**Central Coast Council submission - St Philip's Christian College, Charmhaven (SSD-14082938)**

Thank you for the opportunity to comment on the proposed non-government school, St Phillip's Christian College at Charmhaven. Further to Council's objection dated 2 October 2023, Council provides the following additional concerns in relation to the proposal.

**Above: Plan view of UIA model**

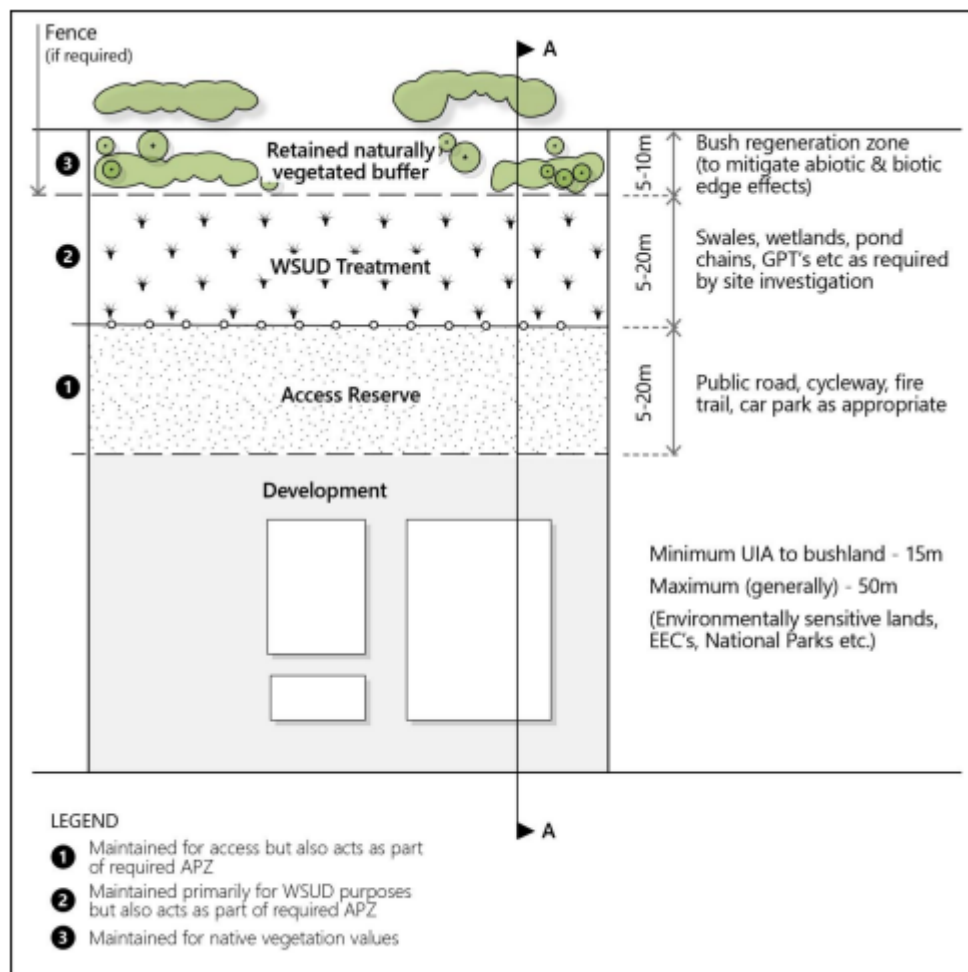
32. Consideration should be given to the creation of urban interface areas (UIA), or similar, where the proposed development interfaces with significant vegetation. The objectives of a UIA are as follows:

- To manage edge effects on retained vegetation
  - To suitably locate bushfire protection and water sensitive urban design (WSUD) infrastructure
  - To provide appropriate access to public lands

- To provide suitable buffers to retained natural watercourses
  - To improve and simplify ongoing management of retained native vegetation and related maintenance costs

The UIA should be applied with reference to the specific characteristics of the site, type of development proposed, type of adjoining vegetation and the ultimate tenure and purpose of tenure. The below figure shows a plan view of UIA model for development abutting significant vegetation.
